# **Groundswell Gloucester**

**Fundamental Flaws in AGL's application  
to frack CSG wells in Gloucester**

# Fundamental Flaws in AGL's application to frack CSG wells in Gloucester (Review of Environmental Factors (REF))

**Figure 2: Sample Deep Slotting Cross Section based on Stage 1A Profile Logs**

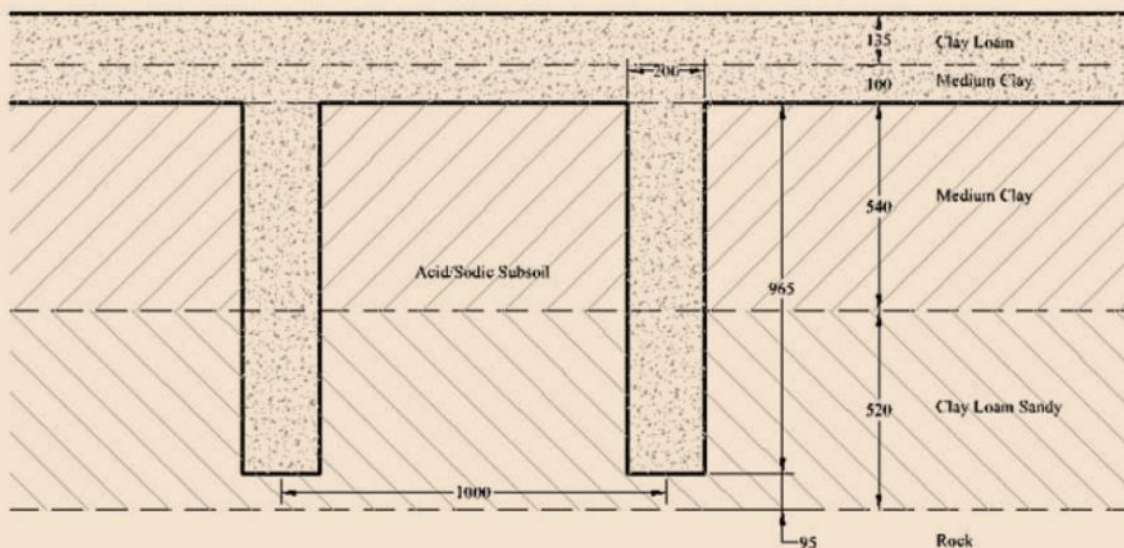
Figure 2 from FK 2012 is copied below and indicates that the slots are 200mm wide and spaced at 1000mm intervals across the surface but FK 2013 says the slots are 1500mm apart. Therefore, 12% of the soil is dug up and the ameliorant mixture is buried. This would not result in a

“thorough mixing of soil ameliorants’ as stated in the paragraph copied above. There will however be subsoil brought to the surface and this is not a good practice on Brown Sodosol soils.

The treatment or composition of the two top layers (135mm and 100mm) in Figure 2 cannot be understood due to lack of information. Section 8 of FK 2012 (reproduced below) provides some more information on this and suggests that the soil removed from the slots and the top 235mm are mixed with the ameliorants; then some of this mixture is put back into the slots and the remainder is spread across the surface at depths varied according to the depth of slots. The soil profile that results from this amount of physical and chemical change will be very complex in both the vertical and horizontal direction. This means that representative sampling will be complicated and require a large number of replications to avoid the bias of the slots.

**FK Report 2012 Figure 4: Stage 1A Trial Irrigation Area showing location of soil sampling site (CS), shallow groundwater samplers (SP, piezometers) and soil moisture sensors (MS)**

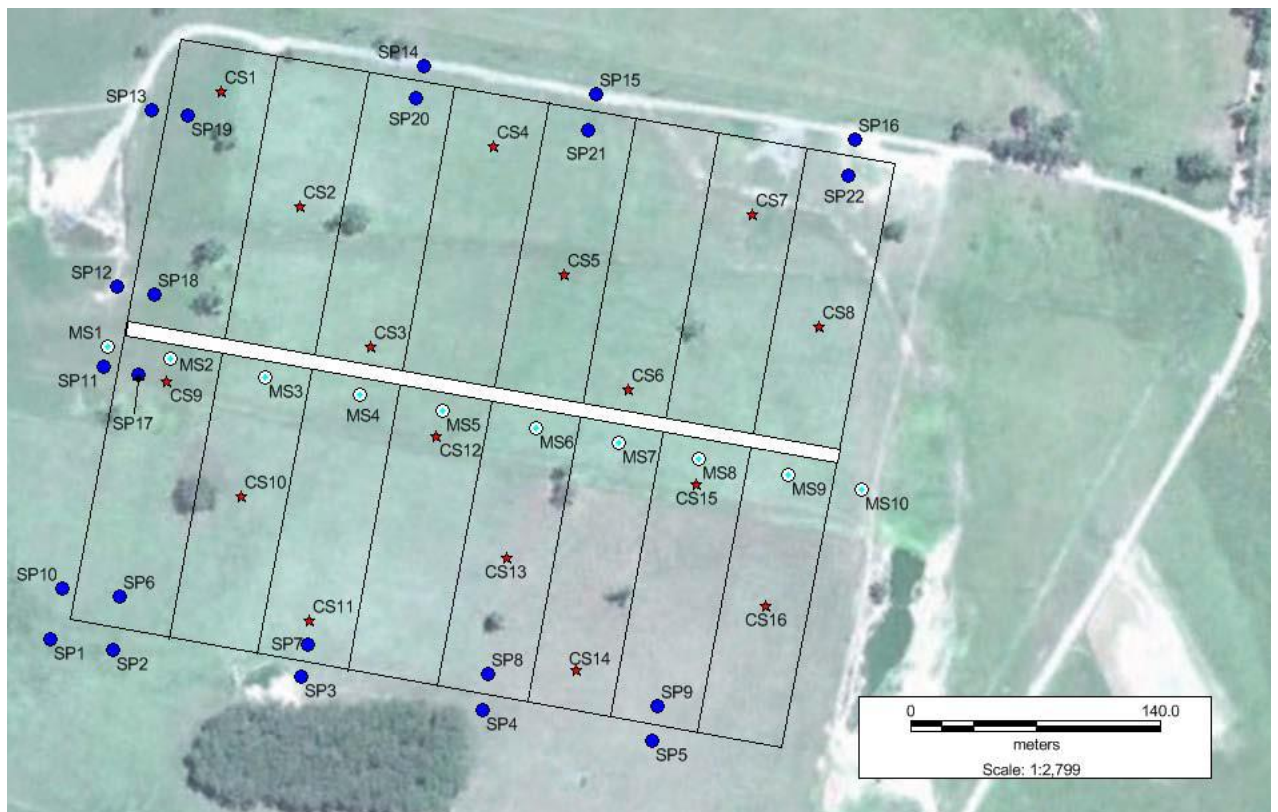
The first dot point is not a reasonable assumption because the variability across the site is so large (FK Annex 1 copied above). A statistical comparison is not possible with such a small sample size.

The second point is not acceptable because the soil surface has been substantially changed due to the trenching process and incorporation of large amounts of ‘ameliorants’. FK2013 Appendix 1 (reproduce here on the next page) indicates that there is a height difference of >10m across the site and can vary by 3-5m in any plot with different slope gradients within various plots.

The third point is incorrect because 1 sample per 0.77ha is not a high density of sampling for such analysis due to the very variable nature of the soil and its characteristics. This variability is demonstrated by the data presented (pages 3 - 4 above) from Annex 1 of FK 2012 that shows the minimum to maximum variations are three fold for many characteristics. There should be at least 7 and preferably 9 sample sites for each plot in order to adequately account for within treatment variation. The location of sample points in relation to the amelioration slots is critical to data interpretation but this is not discussed in FK 2012.

Point four is not true. There is not a sample point for soil moisture or groundwater in each plot. Given the large surface gradient differences, and therefore runoff differences within the plots, there should be at least 7 and preferably 9 sample sites for each plot. The moisture difference at various horizontal distances from the slots will be very large and there will also be interactions between depth of slots and distance.

As presented in Figure 4, the soil sampling sites (CS) are somewhat on the contour lines (mapped in Sheet 01A of Annex 1 FK 2013) but this means they bear no relationship to the soil moisture sampling points (MS) and therefore no possible cause and effect relationships can be analysed between soil moisture and any other soil property. Similarly, there is no analysis possible of any relationship between soil moisture (MS) and groundwater (SP) because of the large spatial differences between sampling sites.

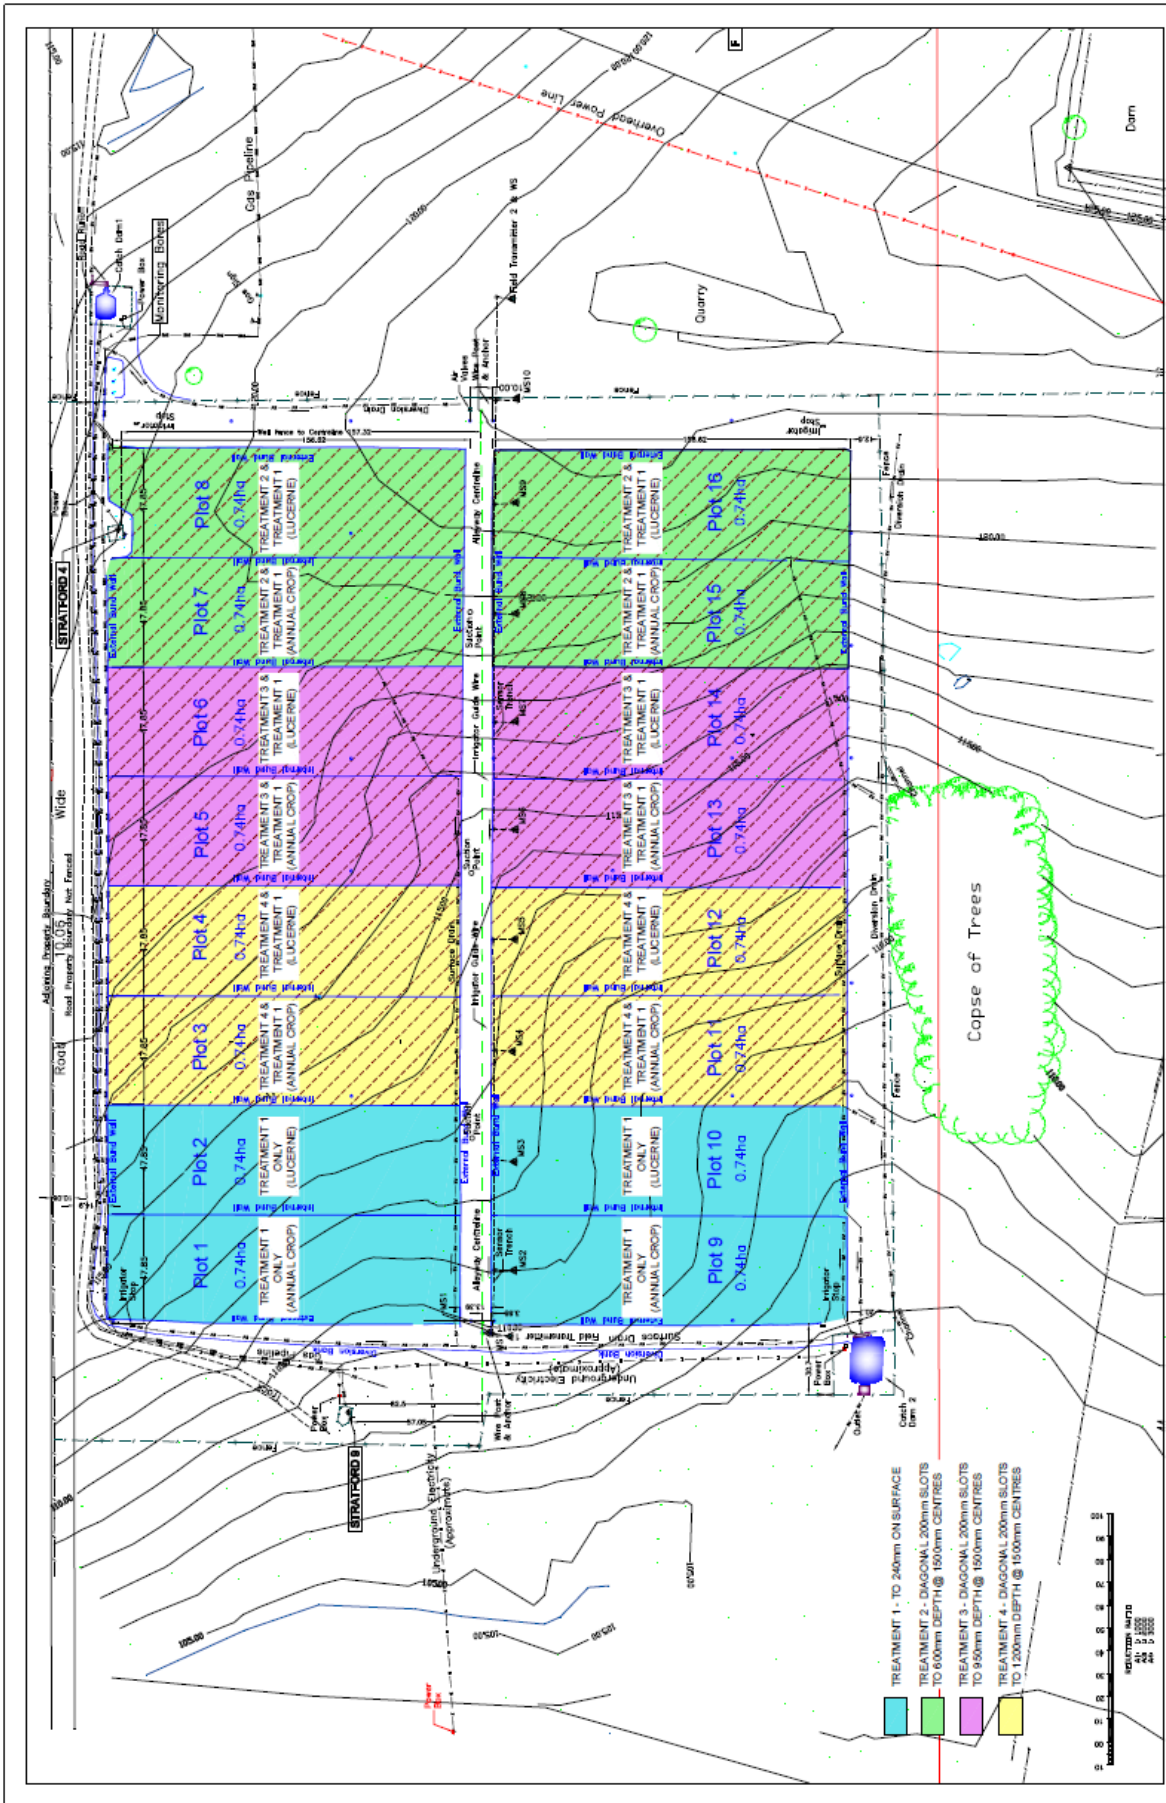
The only interpretation of this can be that the soil is being used as a massive 'sink' for up to 10T salt/ha/yr.

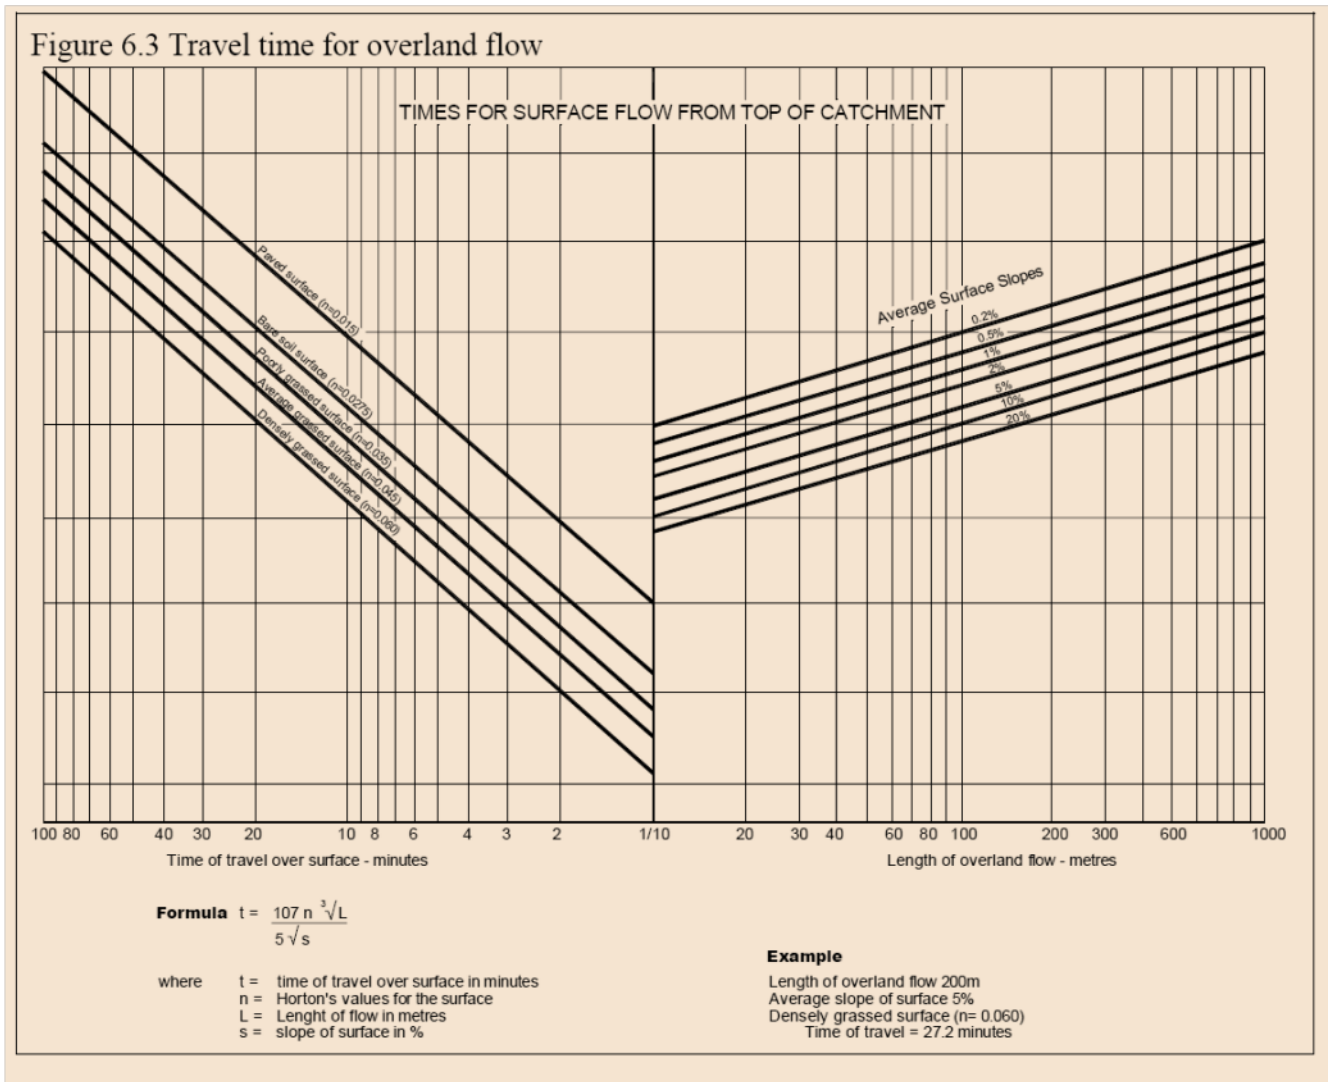
The 'time of concentration' is calculated by summing the travel times of flow in the different hydraulic components. Those components may include overland flow, stream flow and/or flow in structures. Several flow paths may need to be assessed to determine the longest estimated travel time, which is then used to determine rainfall intensity.

The calculation in Section 5.1 uses a rainfall intensity of 11.7mm/hr which from the Report Table 4 page 10 is the average rainfall intensity for a storm lasting 24hour with a 1:100 year return period. That is, the FK 2012 report is suggesting that the time of concentration for the plots is 24hours and this is not correct.

The above quoted nrm.qld.gov.au reference also provides a table (labelled Table 6.3) for calculating the time of concentration of plots and it is copied below.

Measurements for the plots at the Stage 1A site are 47m by 156m (FK 2013) so it can be estimated that the maximum length of overland flow will be about 160m. The land slope is approximately 2% and the surface is a moderately covered pasture. Therefore, the time of concentration for each plot would be about 22 minutes. The runoff is then channelled to the catch dam over a maximum distance of about 400m with a time of concentration of about 10minutes because at this stage it is channelised flow and has a greater velocity (say 0.7 m/s). This gives a total time of concentration of about 32 minutes for the trial area.
